Town of Fort Myers Beach

Project Name: MATANZAS INN & RESORT CPD AMENDMENT
Authorized Applicant: MURPHY PLANNING
LeePA STRAP Number(s): 19-46-24-W4-0150E.0210, 24-46-23-W3-00202.0130, 24-46-23-W3-00202.0150

MASTER CONCEPT PLAN
 MATANZAS INN
 REDEVELOPMENT

Re: DCI2013-0002 Matanzas Inn CPD Amendment

MASTER CONCEPT PLAN
 MATANZAS INN
 EXISTING SITE REDEVELOPMENT

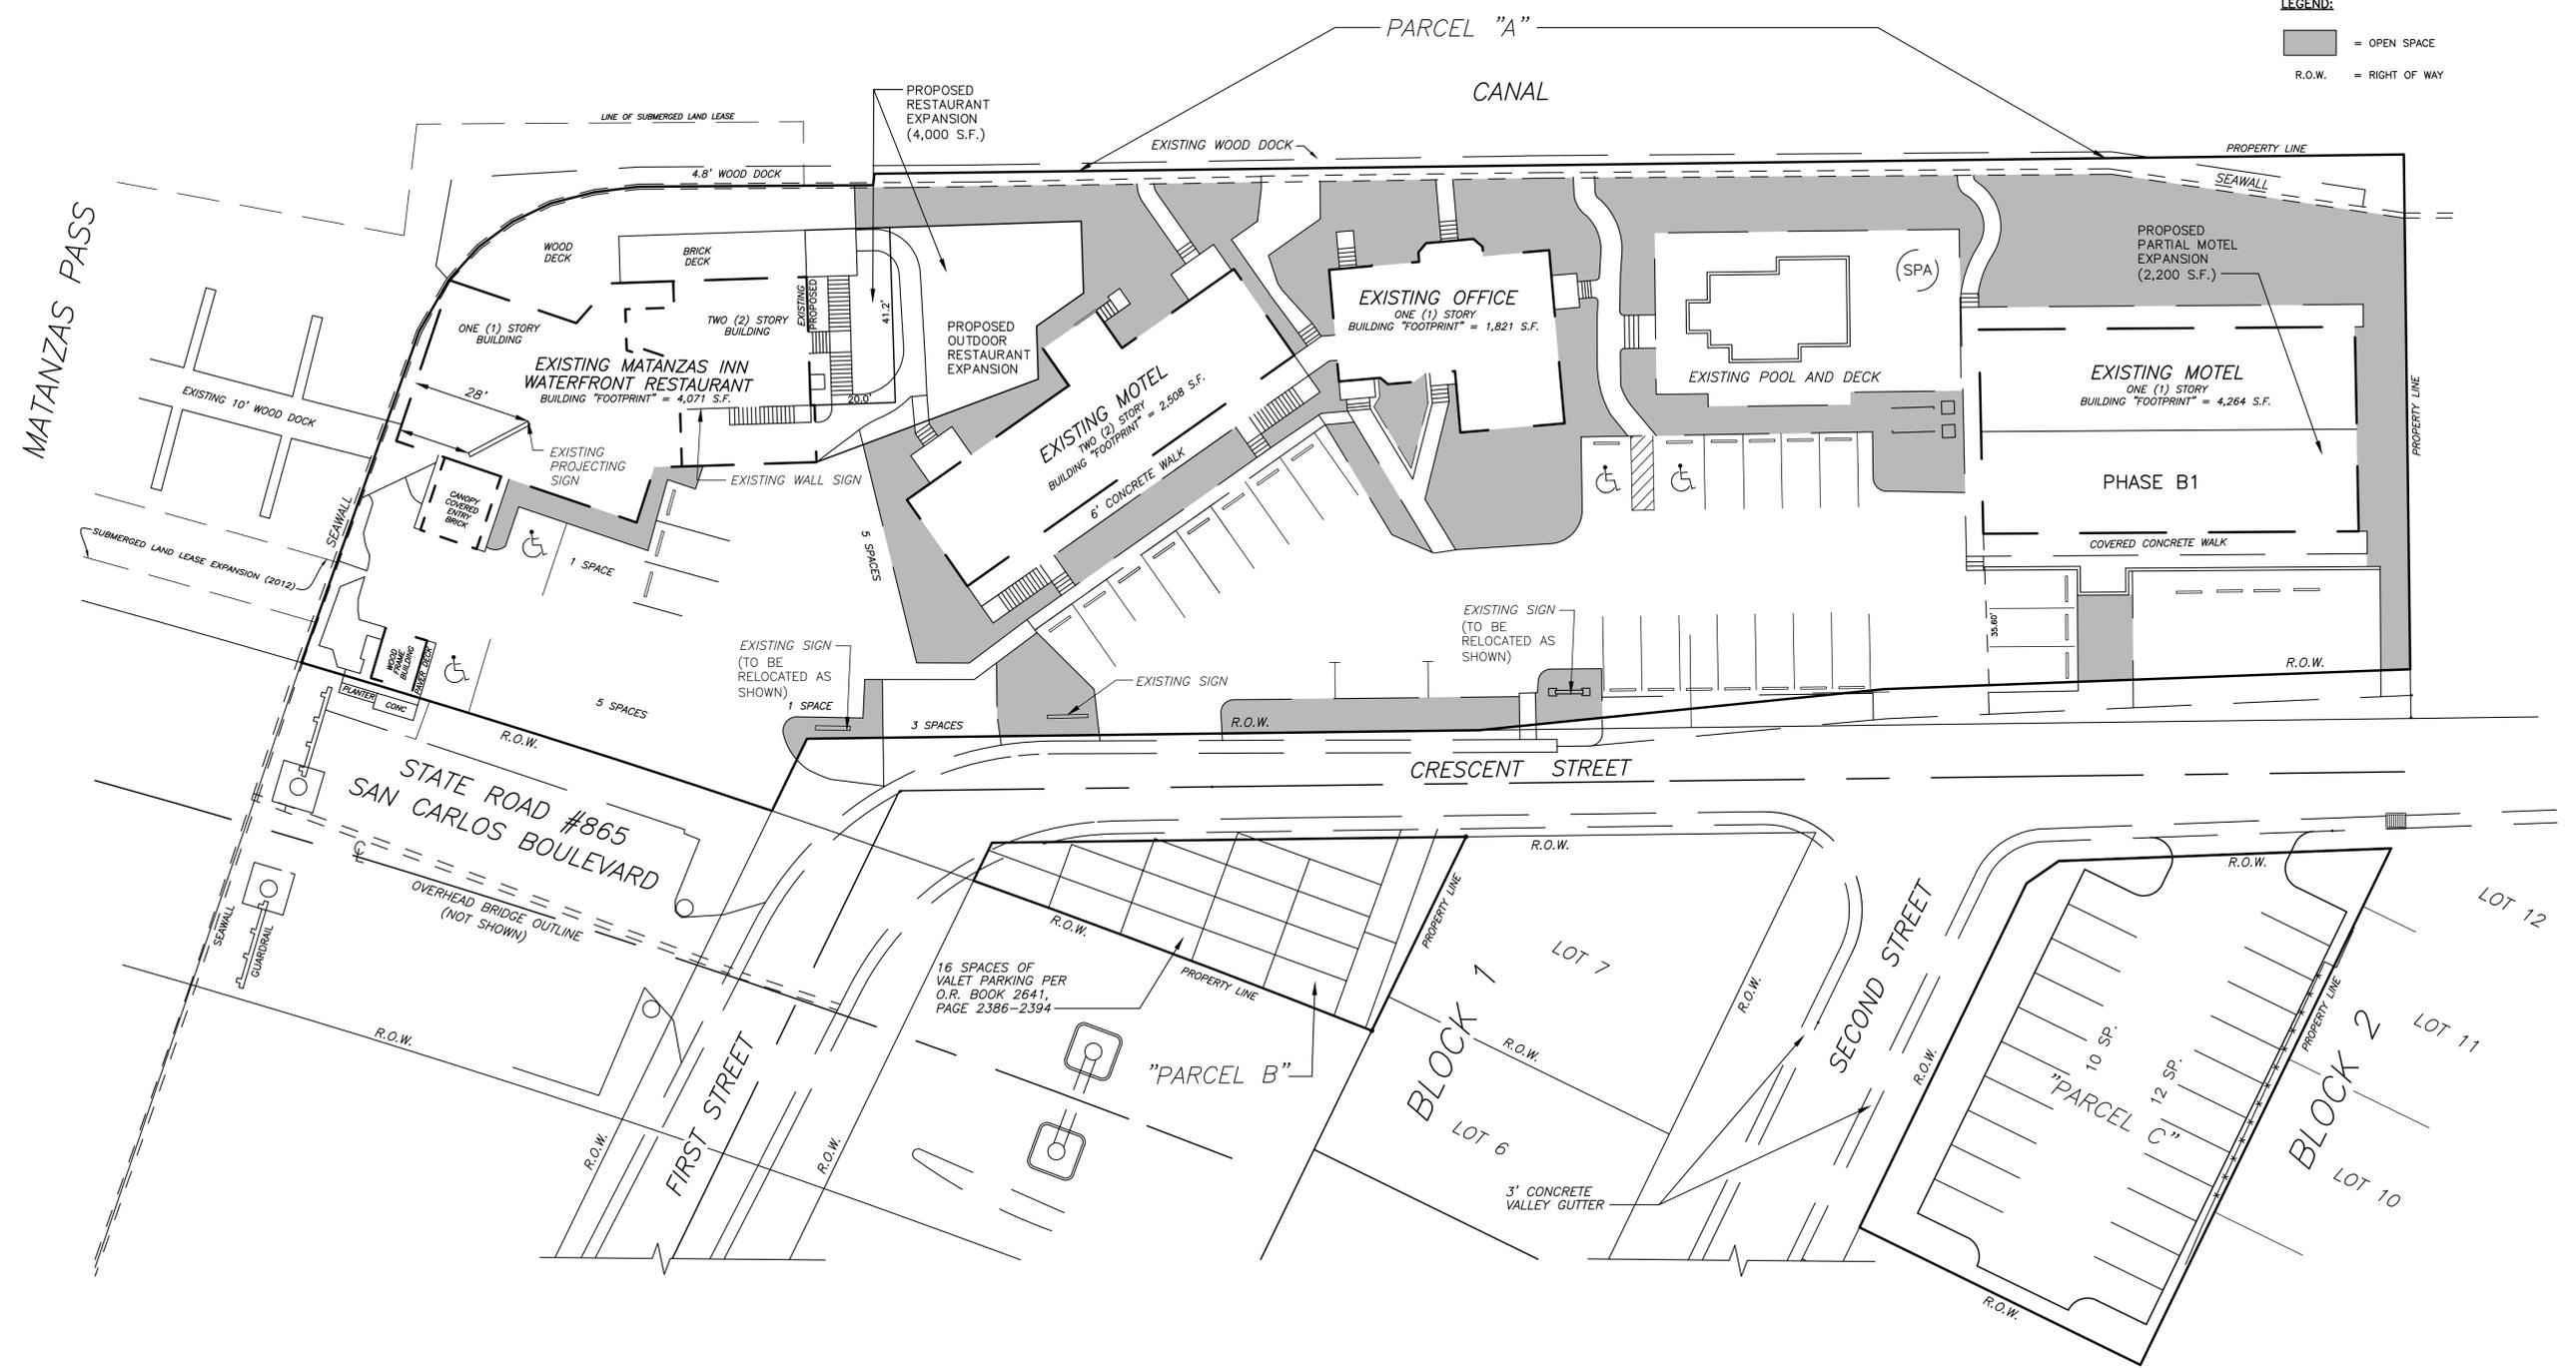
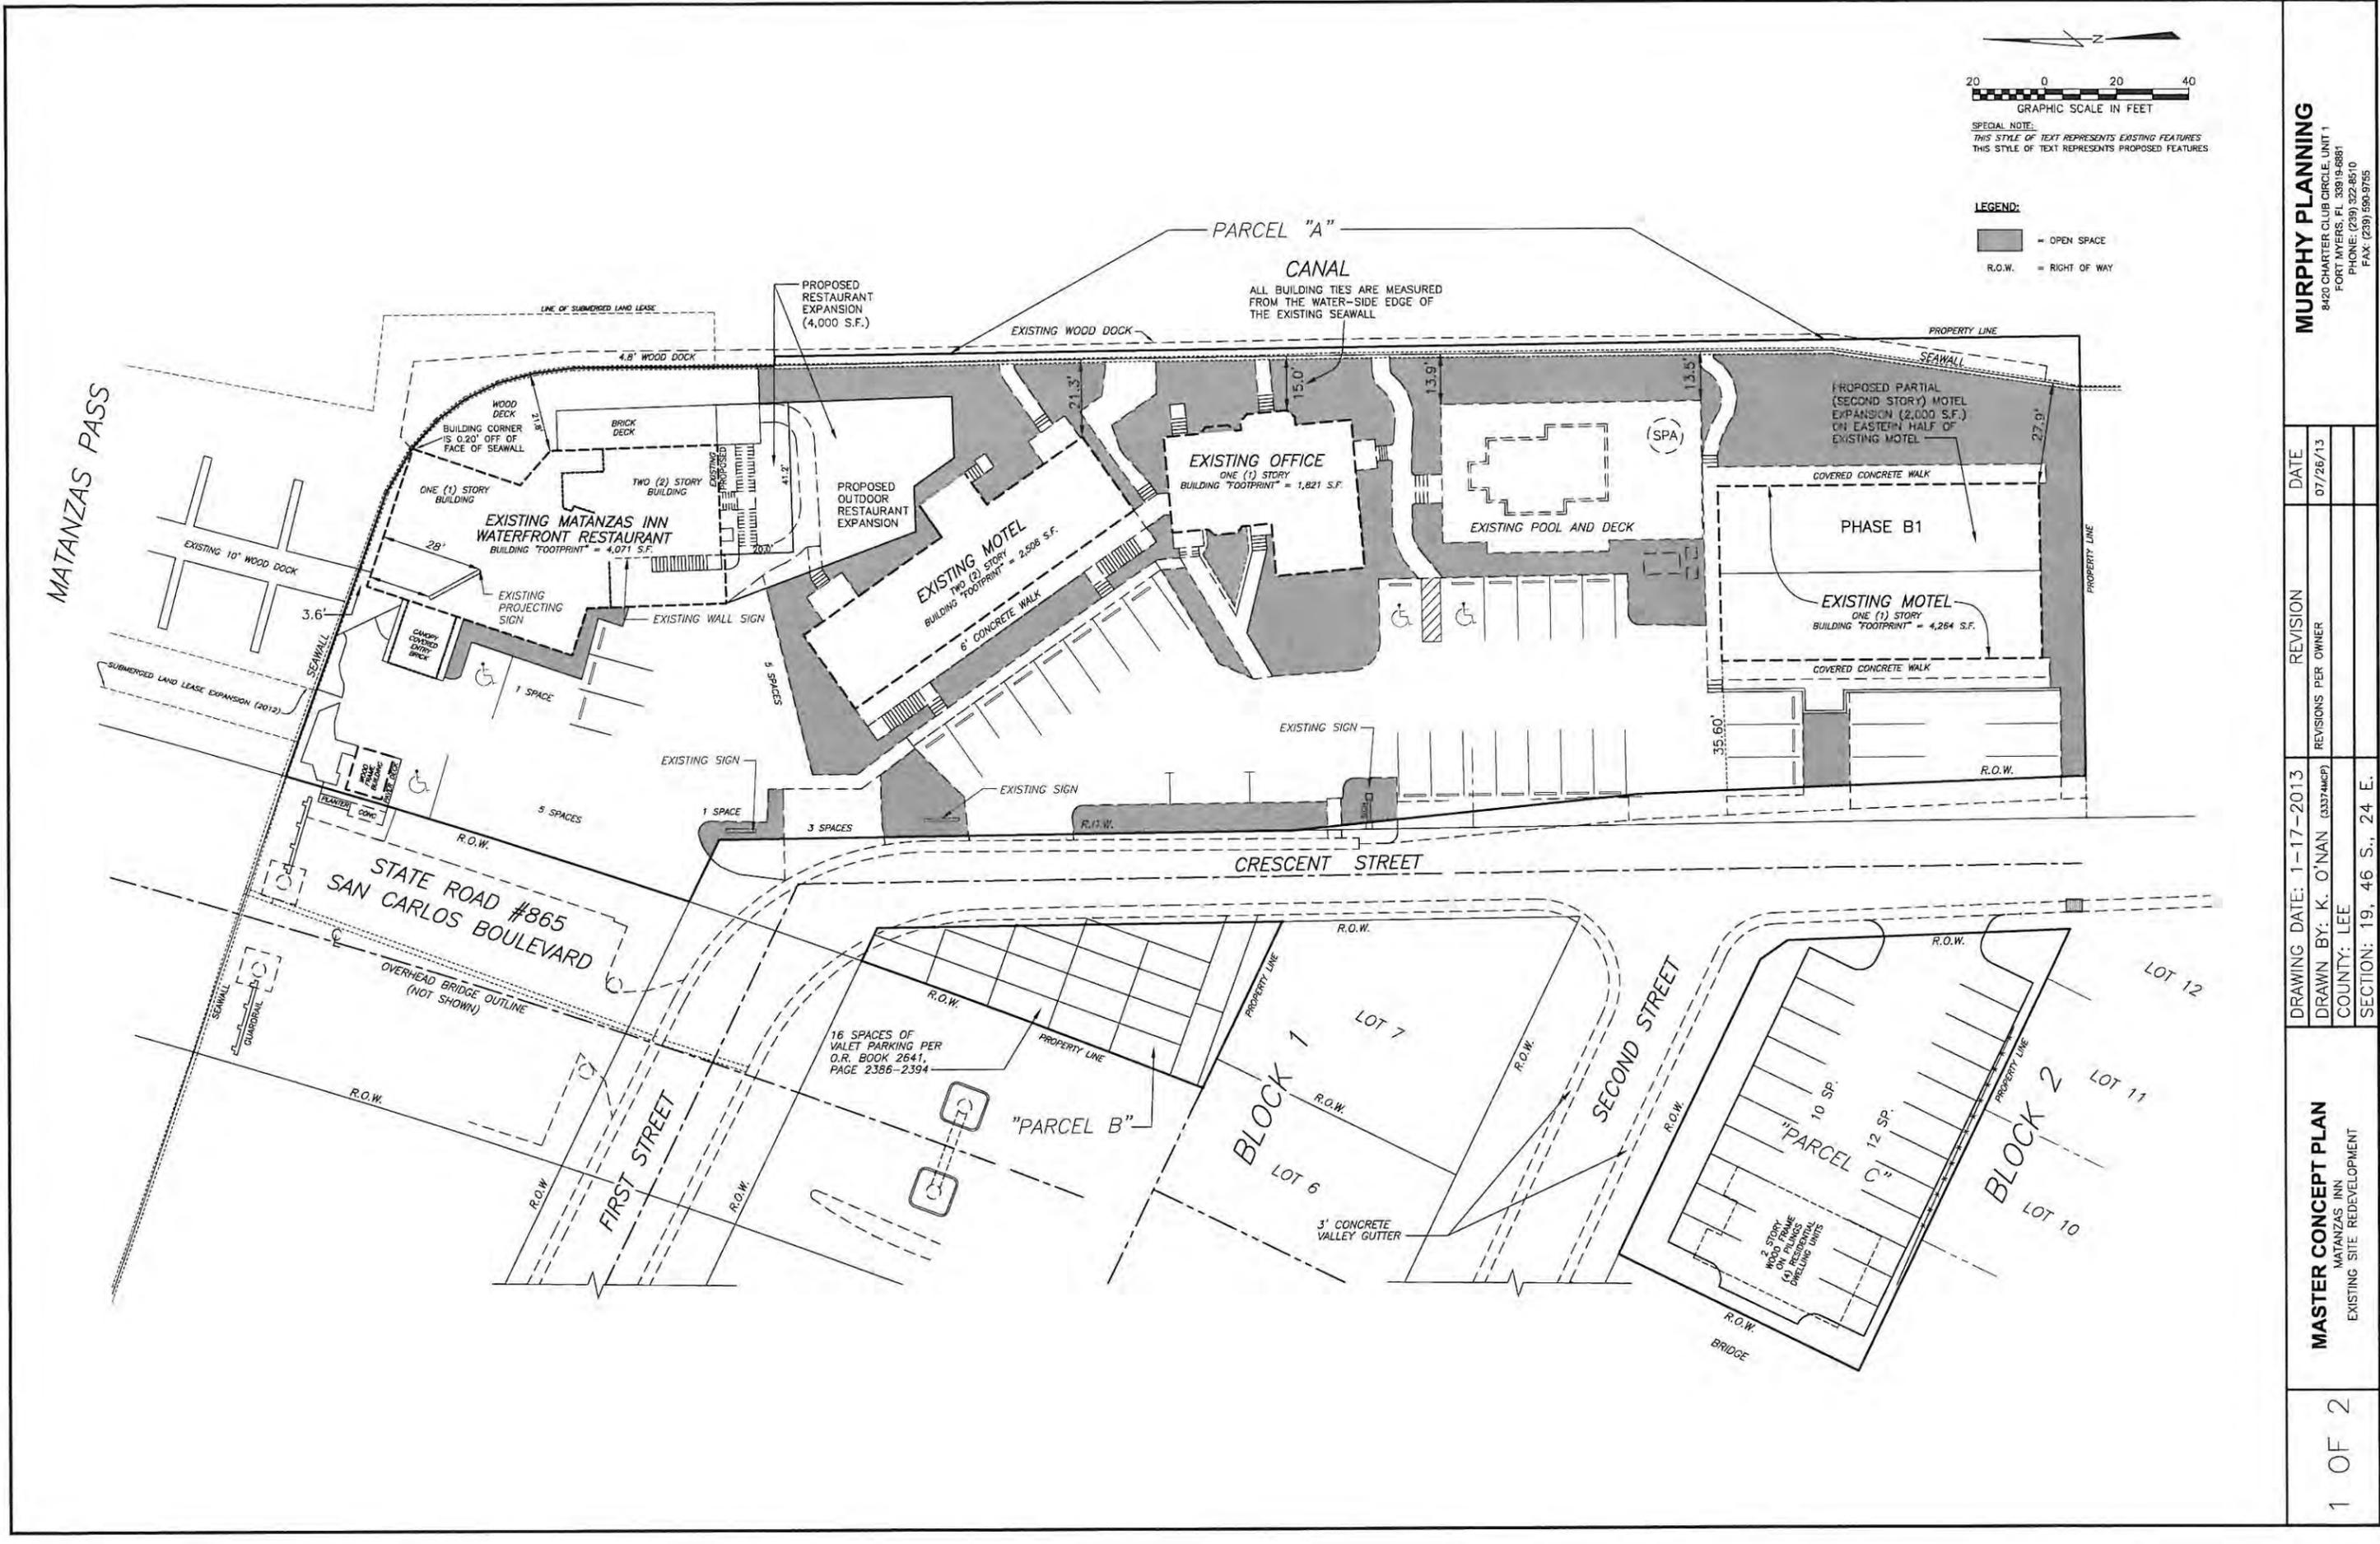
Please include a Phasing Plan, either on the Master Concept Plan or a separate drawing, identifying and indicating the scope of each Phase.

Please label and indicated areas for required buffers or provide a landscape betterment plan indicating compliance with required landscaping and buffers.

Response: Murphy Planning has revised the Master Concept Plan to identify and label phases A through D. Phase B is divided into two sub-phases: Phase B-1 proposes to develop a second floor on to the existing one-story resort motel building along the eastern half of that building facing the canal, totaling 2,200 square feet of additional enclosed building area. This phase is delineated on Master Concept Plan sheet 1 of 2. Phase B-2 proposes to raze the existing one-story resort motel building and replace it with a new two story building.

Response: The MCP has been revised as requested.

Response: The MCP has been revised to identify the phases, and the scope of each phase is indicated in the table provided in response to the request under “Supplement PH-D, B, above.

Response: The MCP has been revised to indicate areas for buffers, landscape betterment, and open space.

Response: The MCP has each building footprint identifies as a phase. Building heights will not exceed 30 feet above base flood elevation and three (3) stories.
